UNITED STATES PATENT AND TRADEMARK OFFICE

APPLICATION NO.	FILING DATE	FIRST NAMED INVENTOR	ATTORNEY DOCKET NO.	CONFIRMATION NO.
10/709,431	05/05/2004	Yi-Lun Chou	12767-US-PA	3430

<p align="center">Office Action Summary</p>	<p>Application No.</p> <p>10/709,431</p>	<p>Applicant(s)</p> <p>CHOU ET AL.</p>	
	<p>Examiner</p> <p>Lucy P. Chien</p>	<p>Art Unit</p> <p>2871</p>

DETAILED ACTION

Fig. 75

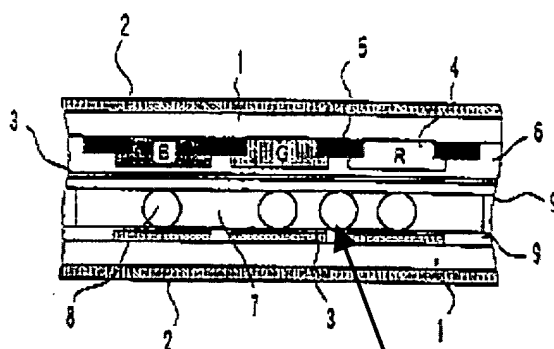
Yoshimura et al discloses (Figure 75) the width of the light-shielding layer (R,B,G) partially overlaps the Black matrix (5).

In addition to the admission, Ikeda et al, and Yoshimura et al as disclosed above, Yoshimura et al also discloses the light shielding layer (R, G, B) exposes a portion of the sealant (Shown below with an arrow pointing to it).
